# PRELIMINARY INFORMATION SHEET (BRIDGE)

PROJECT NAME: **WAITSFIELD**  
 PROJECT NUMBER: **BF 013-4(39)**  
 FILE NAME: z12b136quantity.xlsm PLOT DATE: 10/13/2015  
 PROJECT LEADER: R.YOUNG DRAWN BY: S. MERKWAN  
 DESIGNED BY: VTRANS/D.KULL CHECKED BY: T.KENDRICK  
**PRELIMINARY INFORMATION SHEET 1** SHEET 2 OF 69

REV	DATE	DESCRIPTION
	10/13/2015	NOTE REVISIONS

△ ALTERNATE LONGITUDINAL CLOSURE POUR SECTION

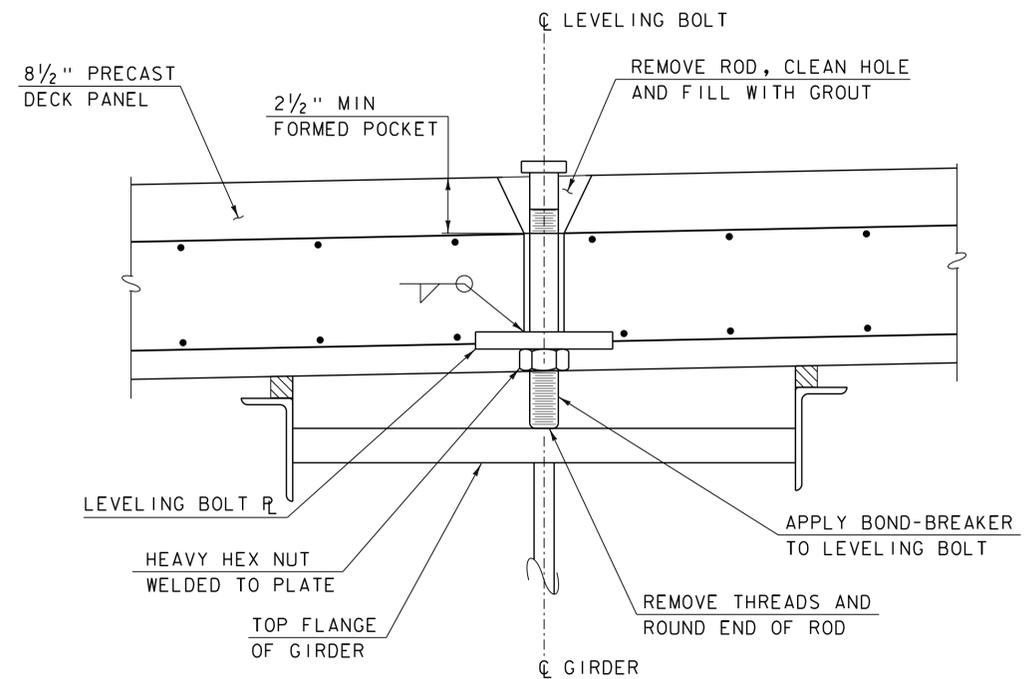
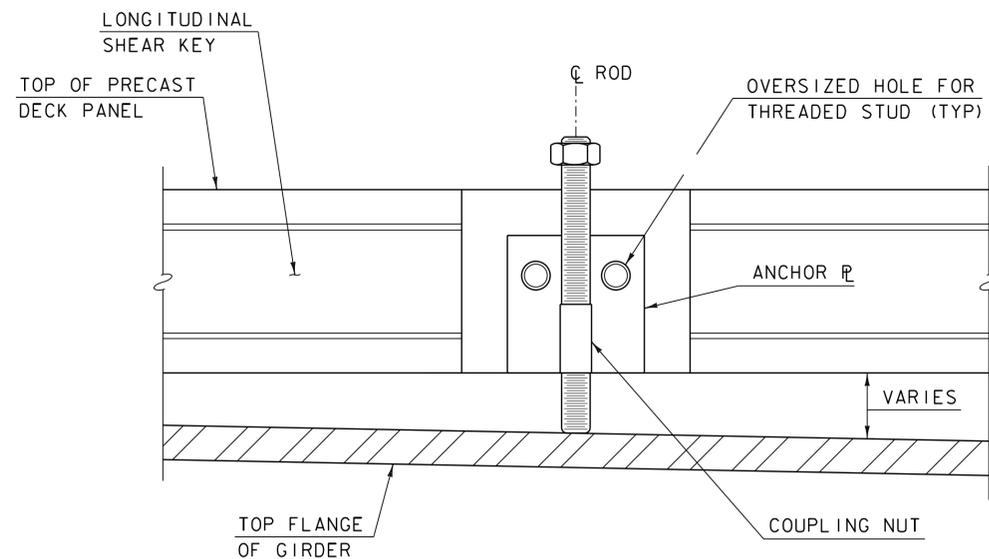
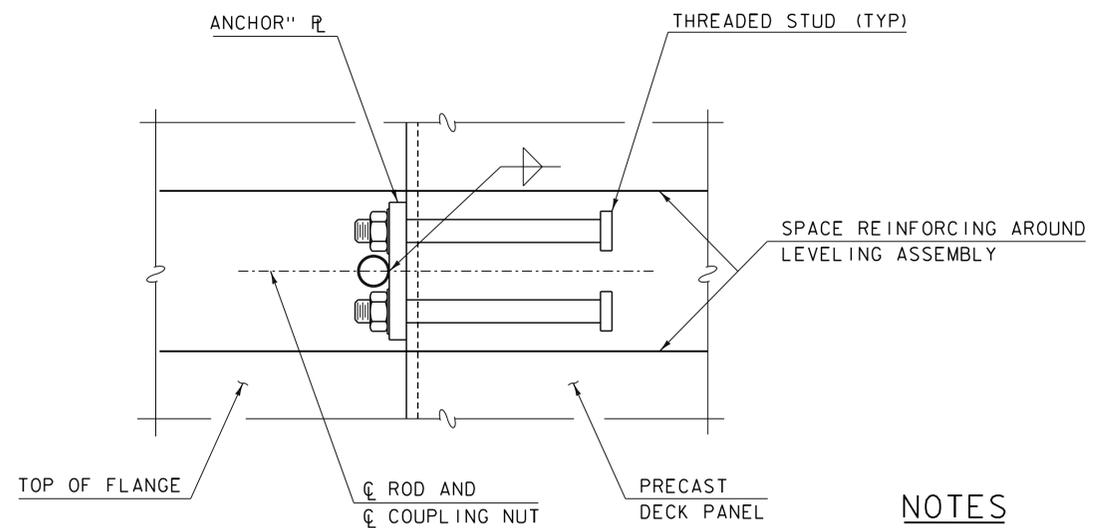
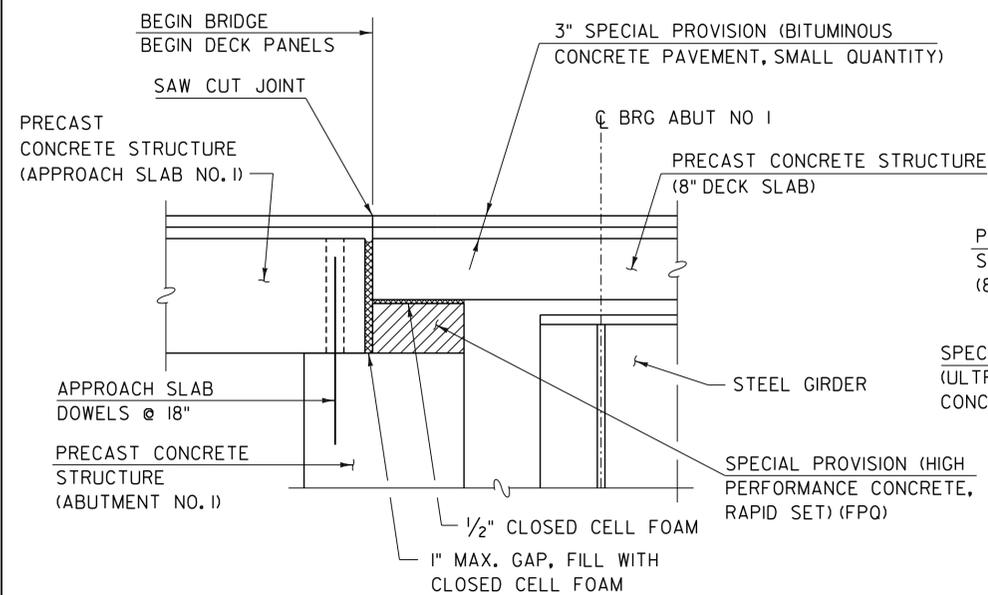
REV	DATE	DESCRIPTION
△	10/13/2015	ALTERNATE CLOSURE POUR ADDITION
△	10/13/2015	SHEET ADDITION

**ABUTMENT NO. 1 PLAN**  
SCALE: 3/8" = 1'-0"

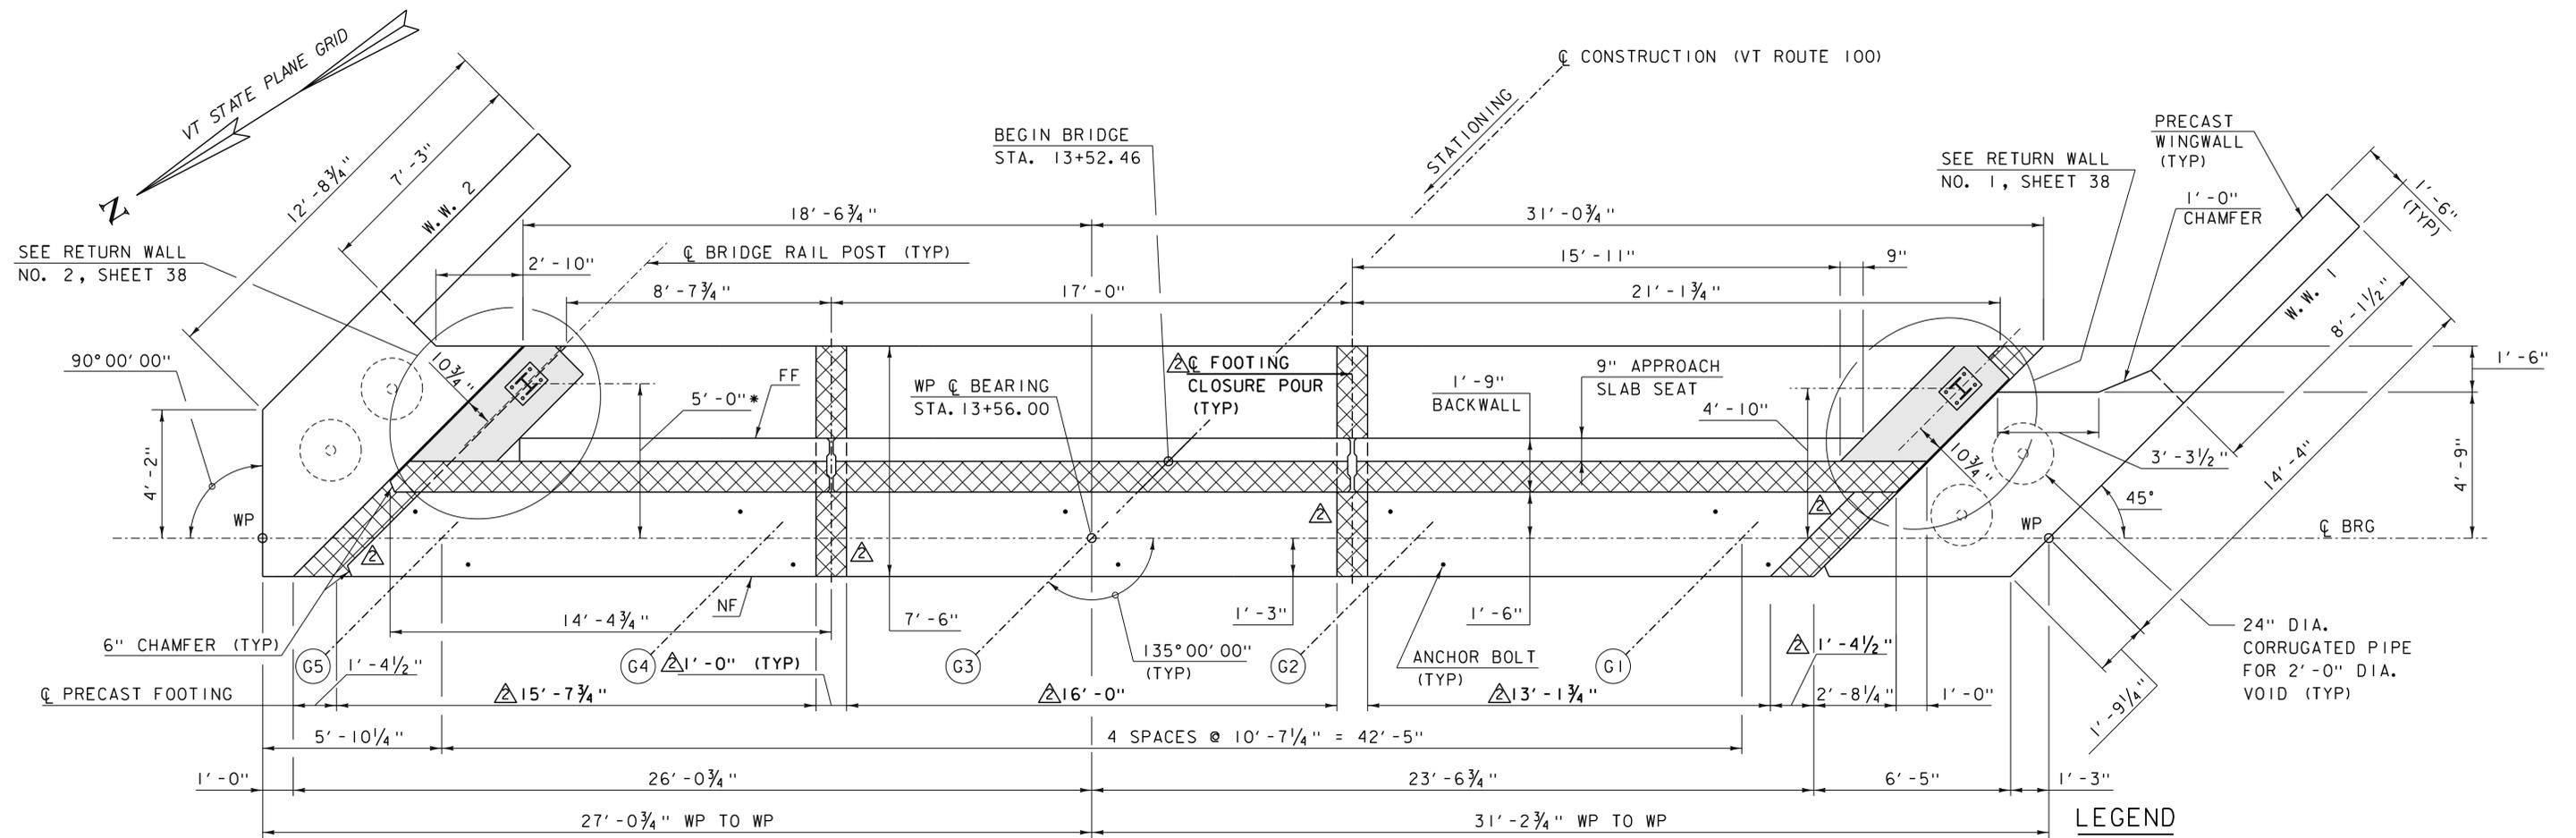
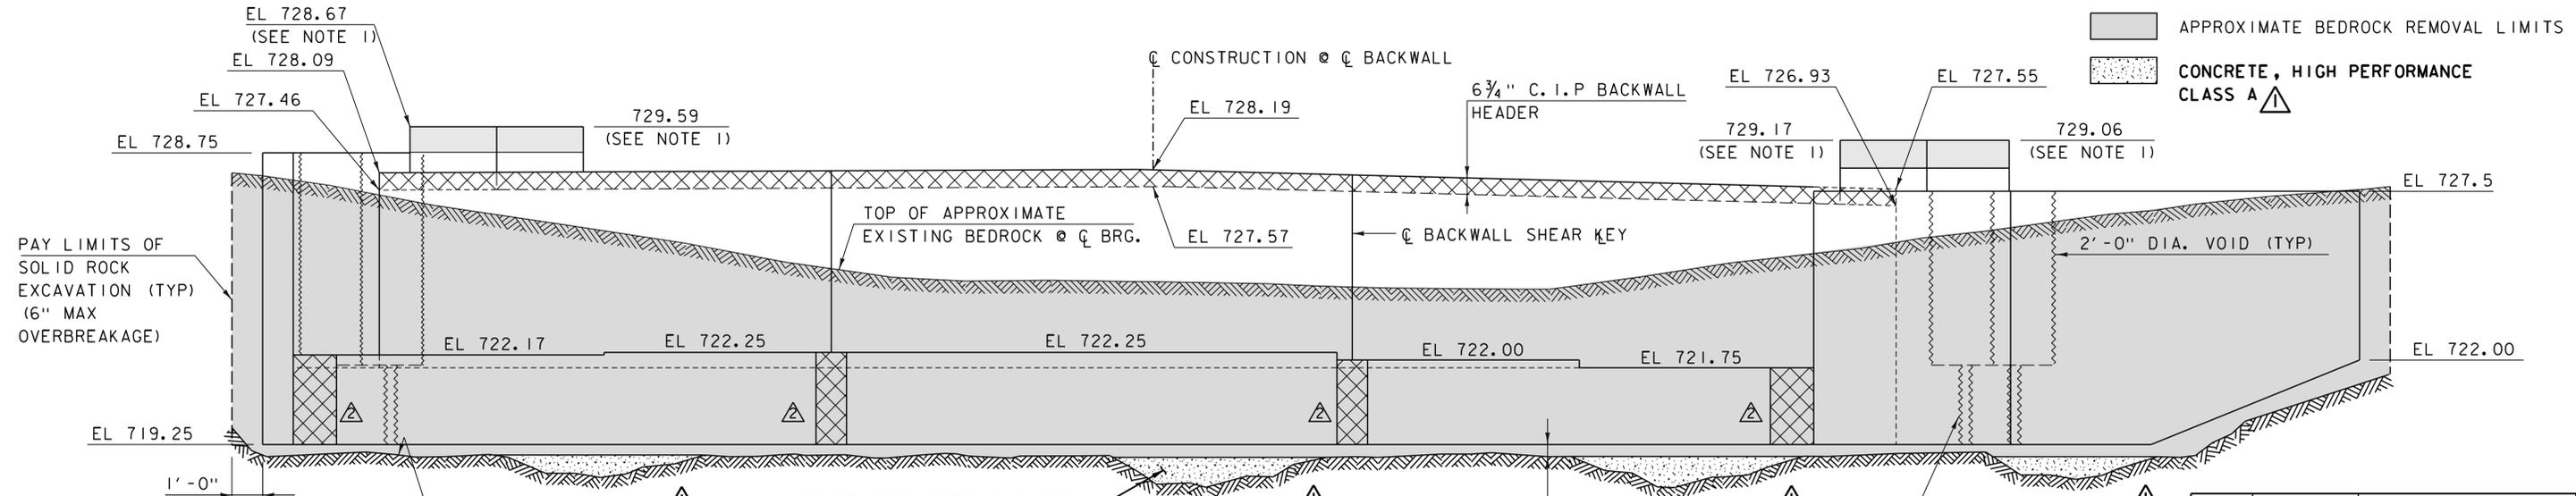
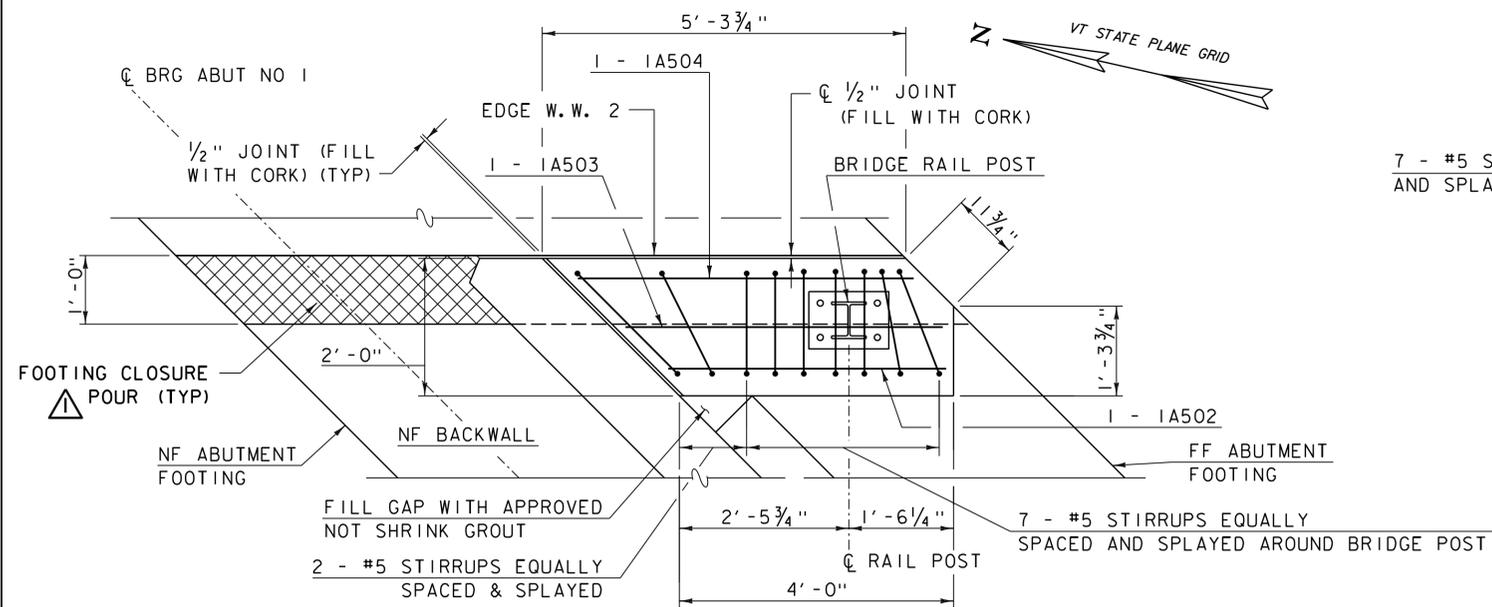
REV	DATE	DESCRIPTION
▲	10/13/2015	SUBFOOTING REVISION
▲	10/13/2015	FOOTING CLOSURE POUR & ELIMINATE POST TENSIONING

**PRECAST FOOTING CLOSURE POUR DETAIL**

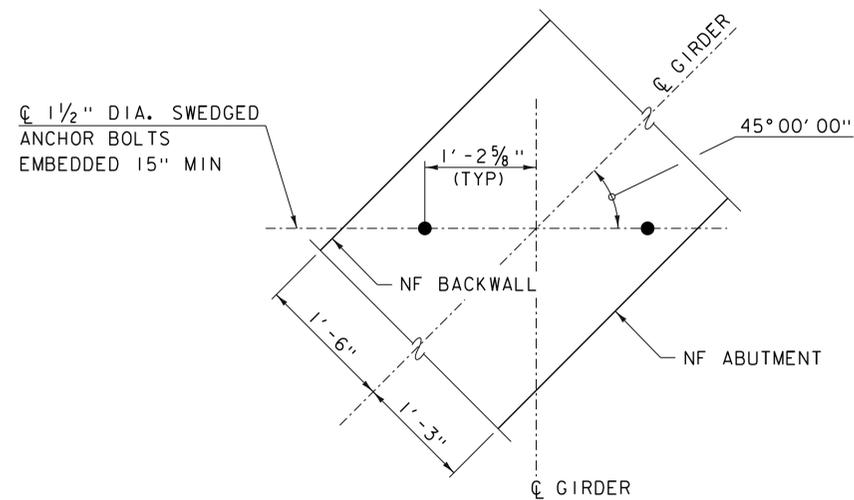
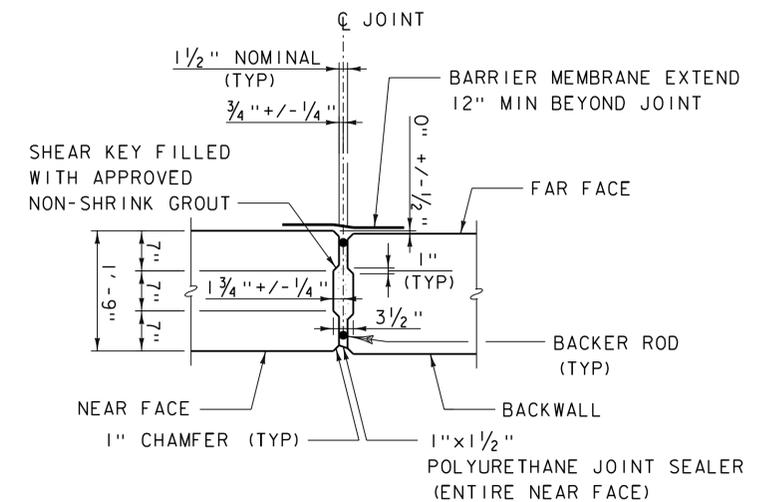
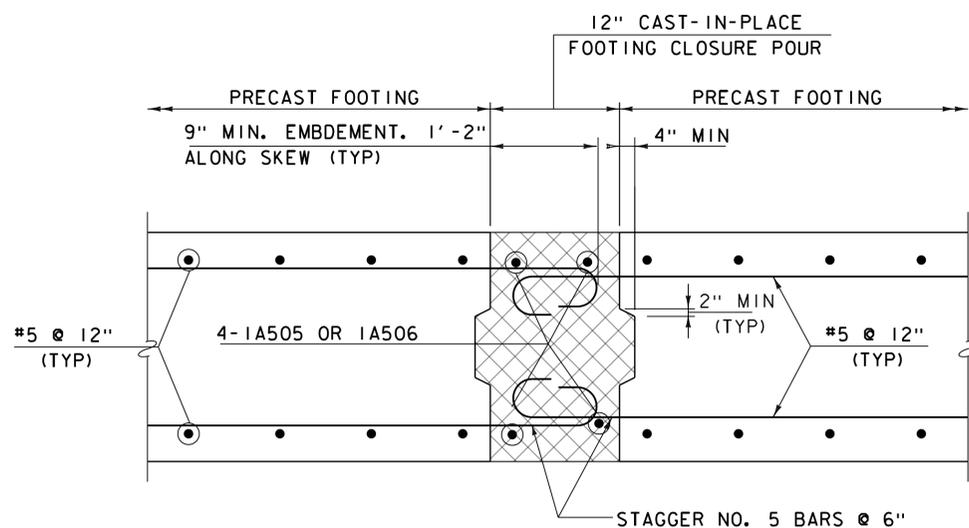
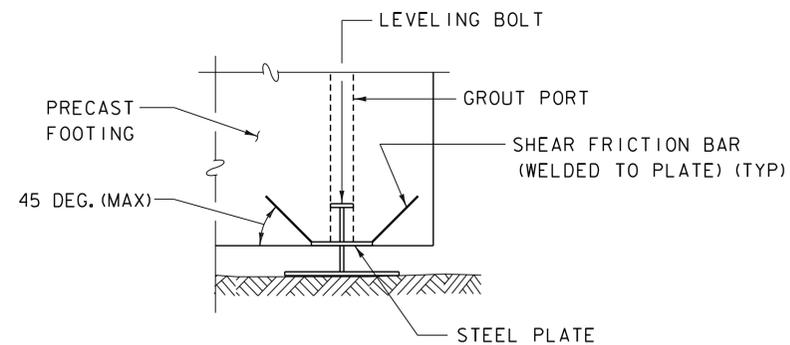
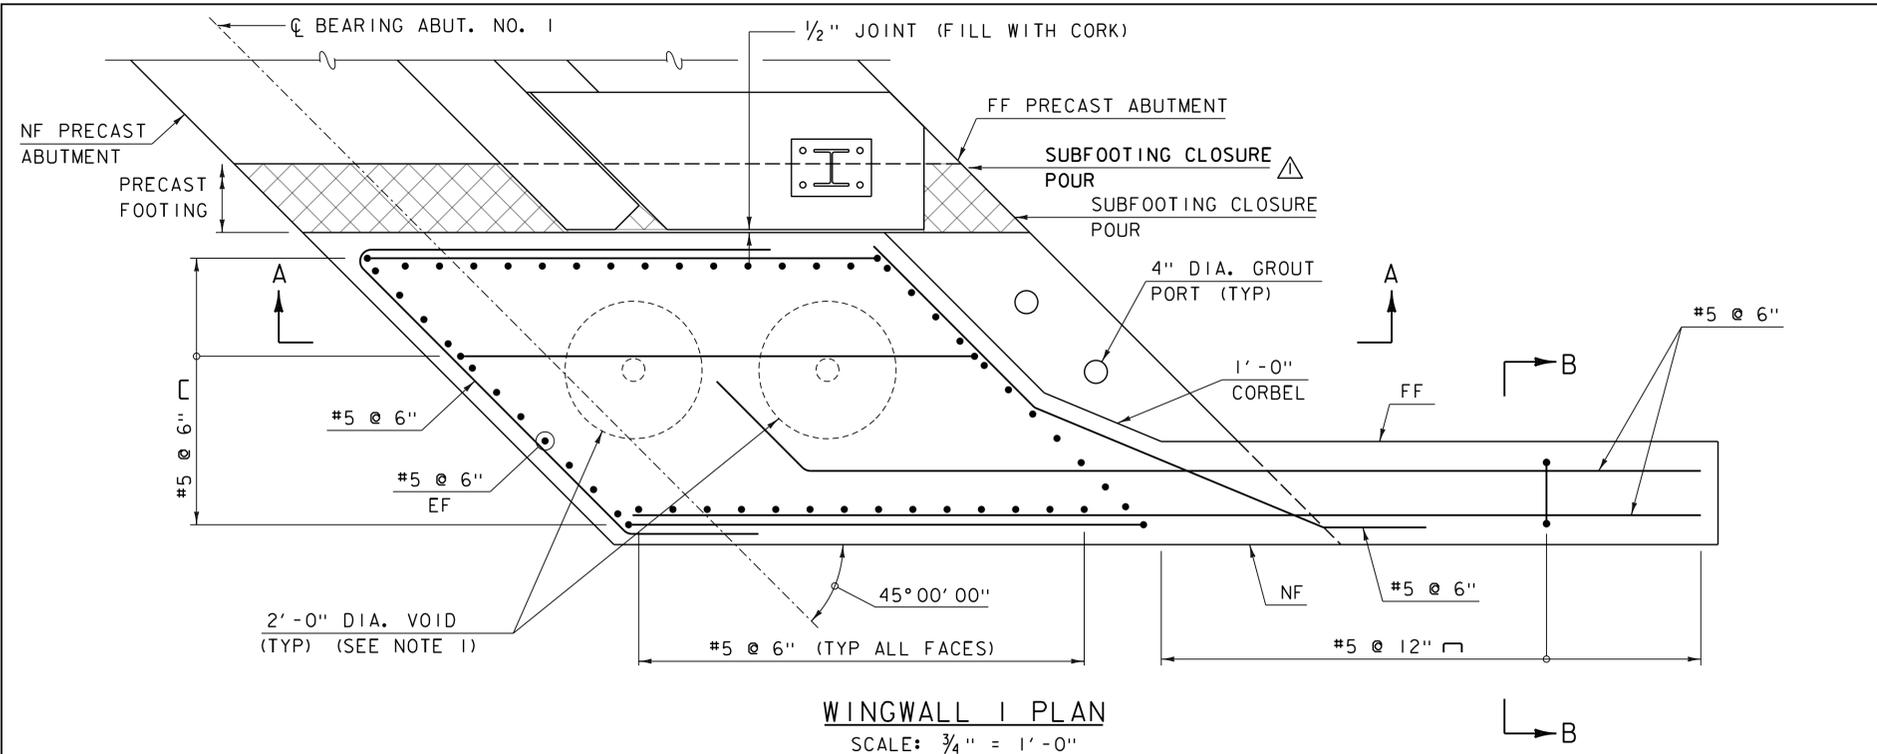
REV	DATE	DESCRIPTION
▲	10/13/2015	FOOTING MATCH CAST JOINT REMOVAL & CLOSURE POUR ADDITION

△ ABUTMENT NO. 1 FOOTING / WINGWALL 1 - FOOTING PLAN  
SCALE: 3/4" = 1'-0"

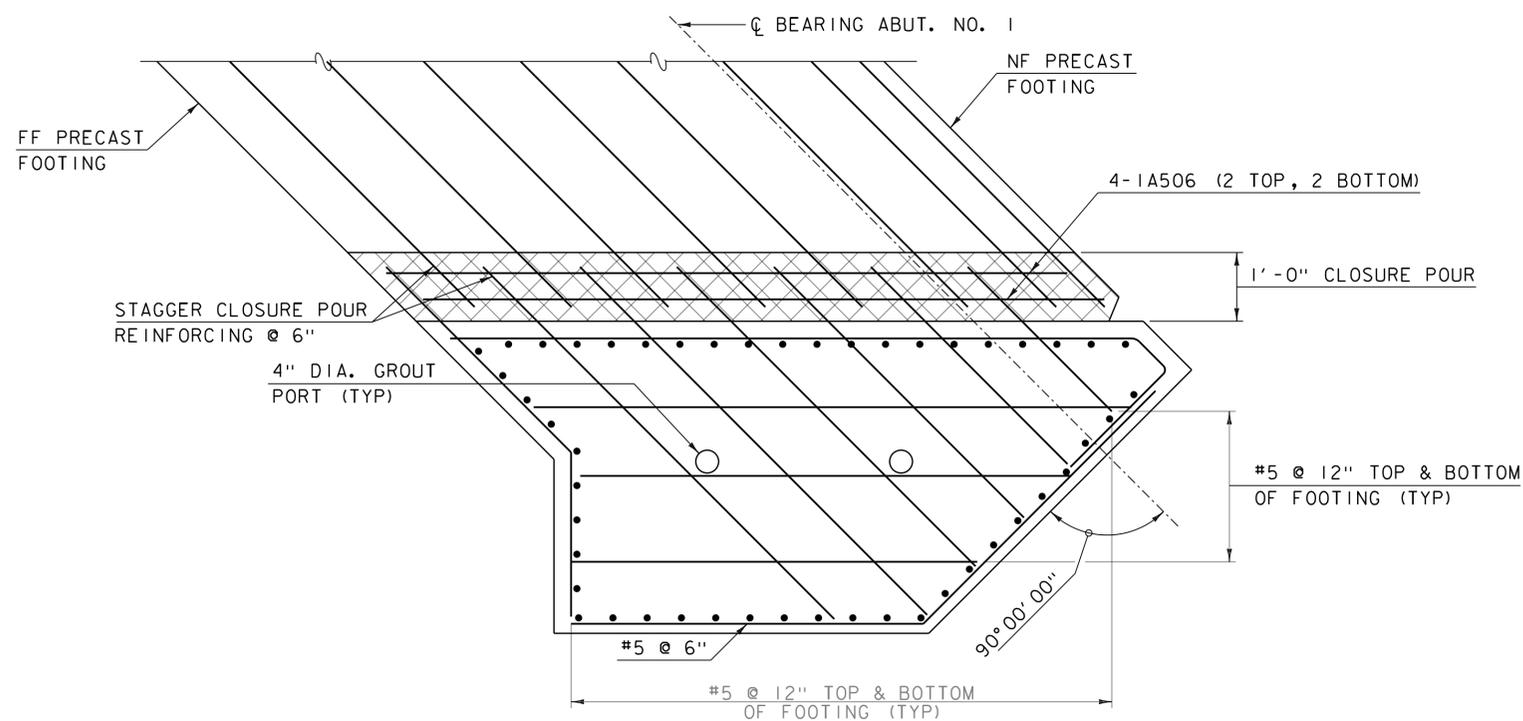
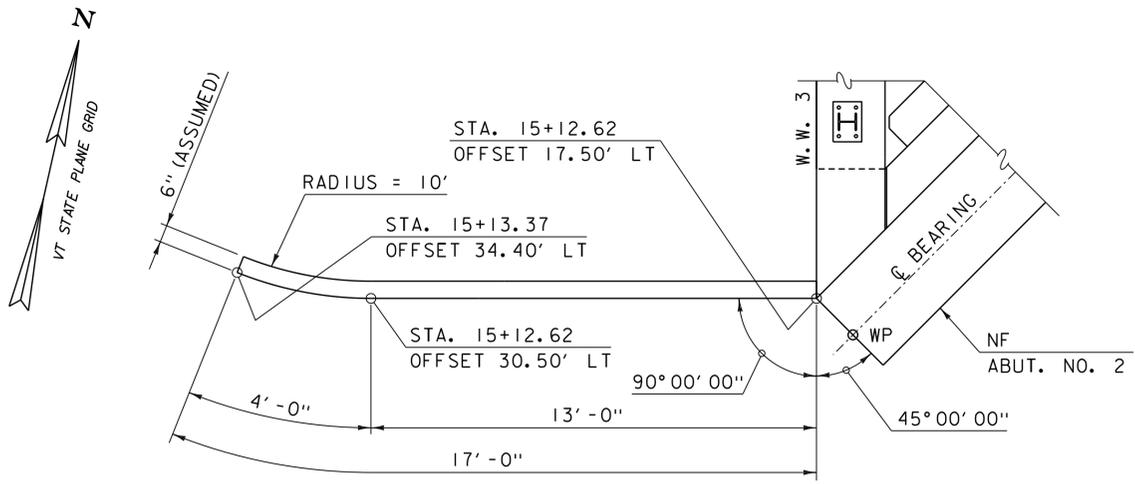
REV	DATE	DESCRIPTION
△	10/13/2015	CLOSURE POUR ADDITION
△	10/13/2015	SHEET ADDITION
